**Summary of response of Save the Northfield Depot (STND) re:
2-14-23 Schematic Design of Pavilion and Transit Hub¹**

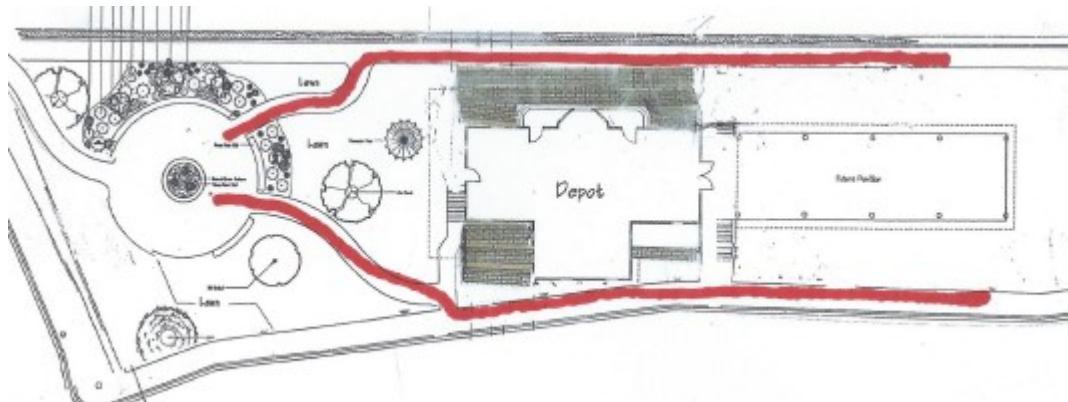
Our preferred roof plan (see below): We propose that the roof of the pavilion and the roof of the depot be adjacent with one gutter system that runs the full width of the pavilion overhang (vs. smaller proposed connecting structure). This plan would address our concerns as follows:

Safety: This design would be much safer by eliminating the four roof valleys and significantly reducing the steps and plaza floor area vulnerability to water and icing.

Integrity. A gutter is not a permanent feature (similar to a solar panel that is allowed on an historical building because it is not permanent and part of the structure), thus, it would not compromise the integrity of the depot.

Aesthetics. A smooth visual transition from one building to another is less distracting and much more in harmony with one another. The roof lines of the depot and pavilion do not compete.

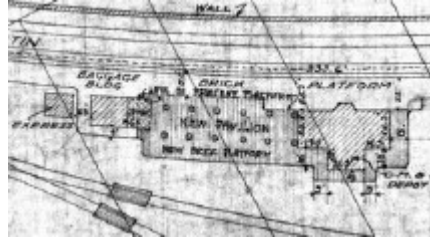
It is not clear from the 2-14-23 drawings that the pavilion is wider than in the first plan. At the first planning meeting there seemed to be a general endorsement of creating a flexible event space vs. a passage in the pavilion as drawn:-

This could be achieved by placing the pavilion columns to be even with the outside E and W walls of the depot (see 1917 drawing below). The overhang on the east side may then provide some weather protection for the ramp; the overhang on the west side could provide protection for bike racks.
